CHANGE REQUEST

⌘ **34.109 CR 010r1** ⌘ rev **-** ⌘ Current version: **4.0.0** ⌘

Title:	⌘ Expanding UE test loop buffering capabilities to enable testing of 2048 kbps radio bearers
Source:	⌘ Ericsson
Work item code:	⌘ TEI Date: ⌘ 2001-06-13
Category:	⌘ F Release: ⌘ REL-4
<p>Use <u>one</u> of the following categories:</p> <p>F (essential correction) A (corresponds to a correction in an earlier release) B (Addition of feature), C (Functional modification of feature) D (Editorial modification)</p> <p>Detailed explanations of the above categories can be found in 3GPP TR 21.900.</p>	
<p>Use <u>one</u> of the following releases:</p> <p>2 (GSM Phase 2) R96 (Release 1996) R97 (Release 1997) R98 (Release 1998) R99 (Release 1999) REL-4 (Release 4) REL-5 (Release 5)</p>

where UE test loop mode 1 LB setup is:

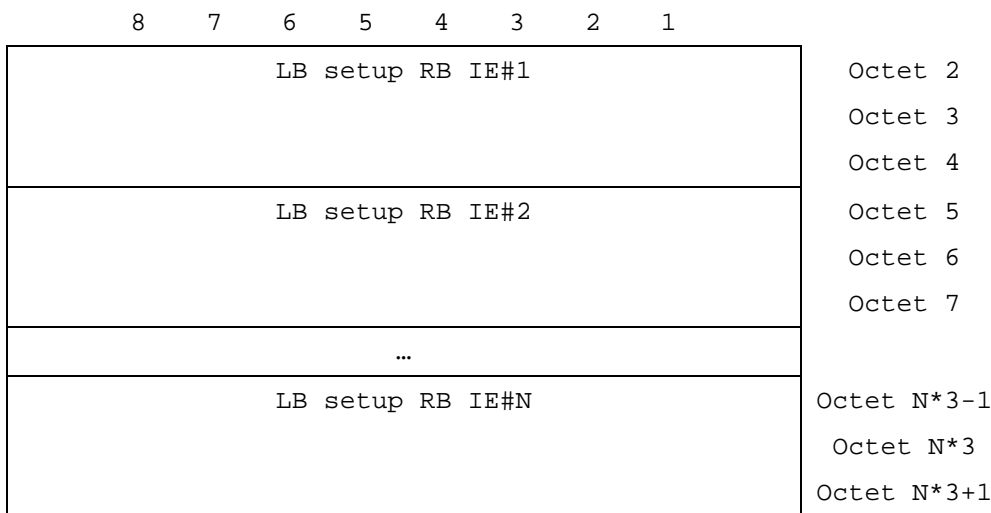
Reason for change:	⌘ Current specification of the CLOSE UE TEST LOOP message limits the range for selecting the UL RLC SDU size to 16383 bits. To enable testing of radio bearers for 2048 kbps data rates then UL RLC SDU size bigger than 16383 bits is needed.
	E.g. for reference radio bearer configuration "Interactive or background / UL:64 DL:2048 kbps / PS RAB / 20 ms TTI" in test case 14.2.35.2 of TS 34.123-1 the required UL RLC SDU size is 41984 bits.
	Backward Compatibility Analysis: The CR is backwards compatible. No new functionality is added.
Summary of change:	⌘ <ul style="list-style-type: none"> • References to TS 25.306 and TS 34.123-2 added to list of references • For the CLOSE UE TEST LOOP message the maximum value for the UL RLC SDU size parameter has been changed from 16383 to 65535.
Consequences if not approved:	⌘ The UE test loop function will not be possible to use for testing of 2048 kbps radio bearers.

8	7	6	5	4	3	2	1	
	Z150	Z140	Z13	Z12	Z11	Z10	Z9	Z8	bit no.
	Z7	Z6	Z5	Z4	Z3	Z2	Z1	Z0	octet 1
	Reserved			Q4	Q3	Q2	Q1	Q0	octet 2
									octet 3

Z153..Z0 = Uplink RLC SDU size in bits 0..6553516383 (binary coded, Z153 is most significant bit and Z0 least significant bit), see Note 1.

NOTE 1: The parameter UL RLC SDU size is only applicable for UE test loop mode 1 and for radio bearers not using the PDCP protocol layer, see 5.3.2.6.2. The UE capability for the parameter UL RLC SDU size is stated by the UE manufacturer as an Implementation Conformations Statement (ICS) as defined in [17] TS 34.123-2, clause A.4.3.1 table A.13. The UE Total RLC AM buffer size according to the UE Radio Access Capabilities defined in [18] TS 25.306 shall not be exceeded.

where UE test loop mode 1 LB setup is:

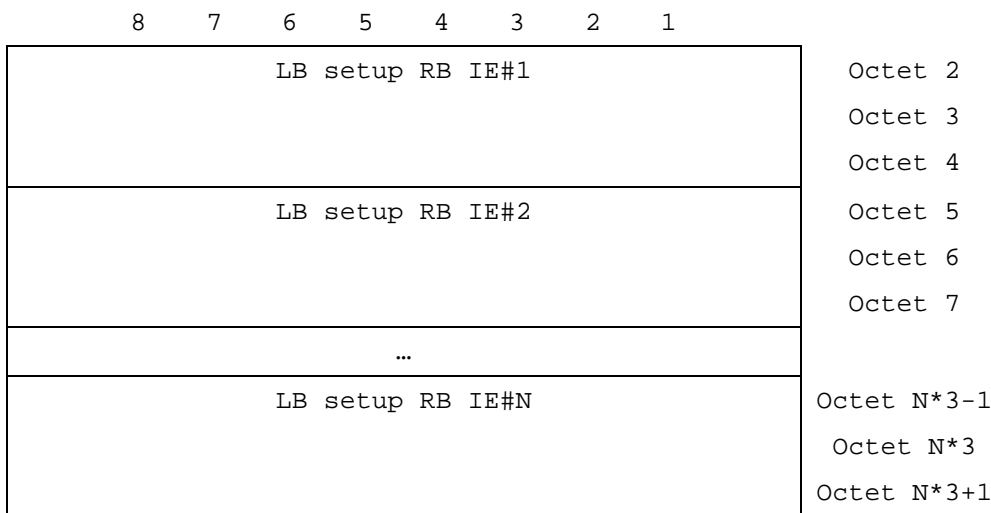
Reason for change:	⌘	Current specification of the CLOSE UE TEST LOOP message limits the range for selecting the UL RLC SDU size to 16383 bits. To enable testing of radio bearers for 2048 kbps data rates then UL RLC SDU size bigger than 16383 bits is needed. E.g. for reference radio bearer configuration "Interactive or background / UL:64 DL:2048 kbps / PS RAB / 20 ms TTI" in test case 14.2.35.2 of TS 34.123-1 the required UL RLC SDU size is 41984 bits. Backward Compatibility Analysis: The CR is backwards compatible. No new functionality is added.
Summary of change:	⌘	<ul style="list-style-type: none"> • References to TS 25.306 and TS 34.123-2 added to list of references • For the CLOSE UE TEST LOOP message the maximum value for the UL RLC SDU size parameter has been changed from 16383 to 65535.
Consequences if not approved:	⌘	The UE test loop function will not be possible to use for testing of 2048 kbps radio bearers.

8	7	6	5	4	3	2	1	
	Z150	Z140	Z13	Z12	Z11	Z10	Z9	Z8	bit no.
	Z7	Z6	Z5	Z4	Z3	Z2	Z1	Z0	octet 1
	Reserved			Q4	Q3	Q2	Q1	Q0	octet 2
									octet 3

Z153..Z0 = Uplink RLC SDU size in bits 0..6553516383 (binary coded, Z153 is most significant bit and Z0 least significant bit), see Note 1.

NOTE 1: The parameter UL RLC SDU size is only applicable for UE test loop mode 1 and for radio bearers not using the PDCP protocol layer, see 5.3.2.6.2. The UE capability for the parameter UL RLC SDU size is stated by the UE manufacturer as an Implementation Conformations Statement (ICS) as defined in [17] TS 34.123-2, clause A.4.3.1 table A.13. The UE Total RLC AM buffer size according to the UE Radio Access Capabilities defined in [18] TS 25.306 shall not be exceeded.
